Revised Proposal

Several revisions were made to the proposal in response to public and Town feedback:

Architectural Design – Elevations

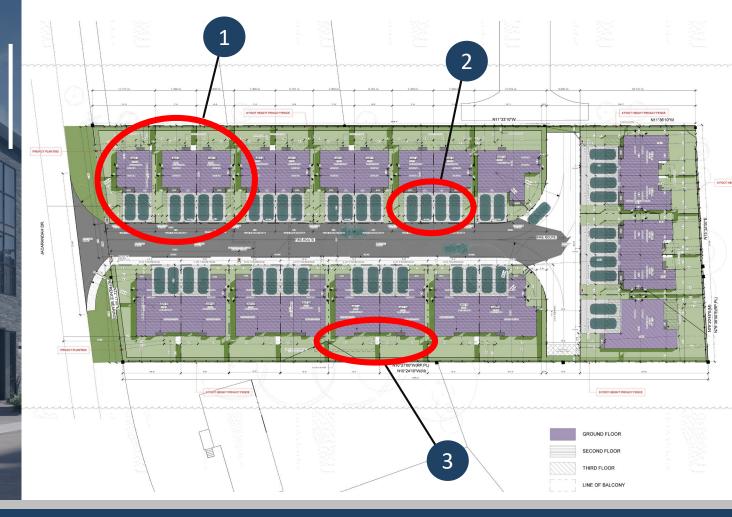
- Reduced windows in size and number
- Removal of upperstorey balconies/ decks
